Oxfordshire Strategic Rail Freight Interchange

Response to non-statutory consultation

June 2022

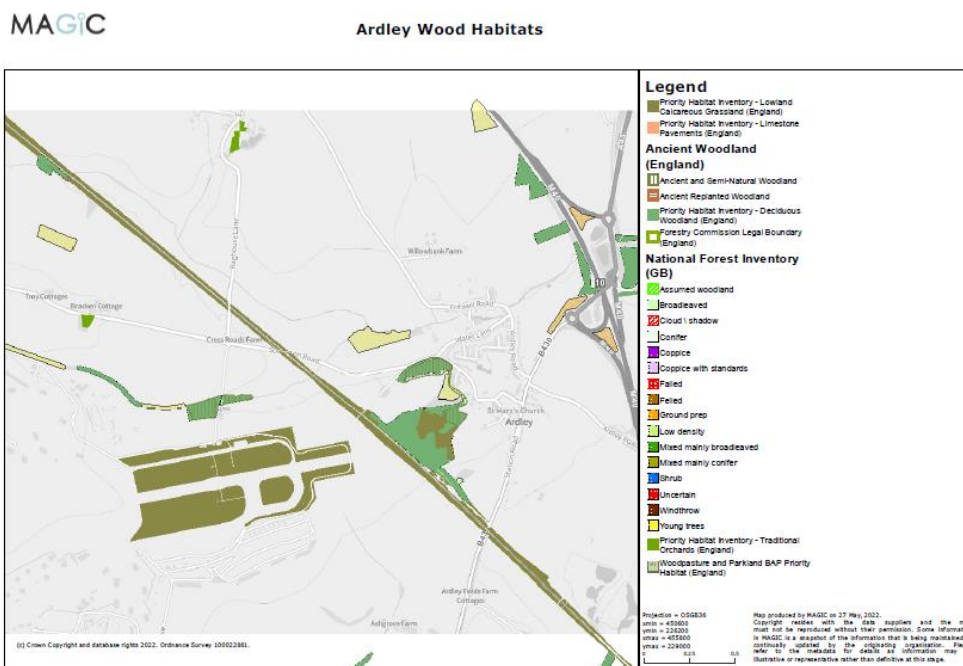
14. There is one area of Oxfordshire County Council (OCC) land that appears to be affected (other than highway land) and that is part of the Ardley Wood Quarry site (See below OCC land ownership plan for Ardley Wood, and the scheme works plan with the works area No 26 circled in blue that affects the OCC land).

15. We would like to seek clarification of the purpose of the new access (Works No 26) and remind the applicant that the land is held for countryside / recreation purposes and contains a variety of Priority Habitats (See map below from the Government's 'Magic.gov.uk' website) which may not be compatible with the use for which the land is held.
